# PRODUCT REFERENCE MEMO

## AVAILABILITY OF SPIRALLOCK FLANGE NUTS FOR 040-21101 WHEEL ASSEMBLY

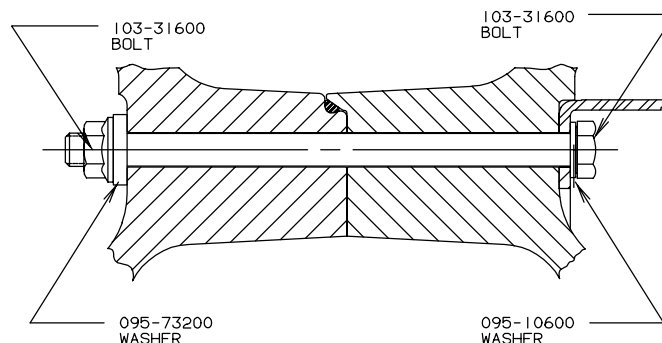
2. At next wheel service (or sooner at owner's option) reassemble each wheel using the Spirallock nuts P/N 094-16700 in place of the original nuts P/N 094-91500; torque at 300 in-lbs. The Spirallock nuts must be oriented with the 3/4" flange facing the washer P/N 095-73200 as shown below:

NOTE: Spirallock nut P/N 094-16700 is a flange nut with a 9/16" hex and a 3/4" flange diameter.

Be aware that the Spirallock nuts utilize a unique locking feature which will continue to be effective for the life of the wheel. It is normal for this style nut to be free spinning, requiring a very low "run-up" torque as compared to the original nuts.
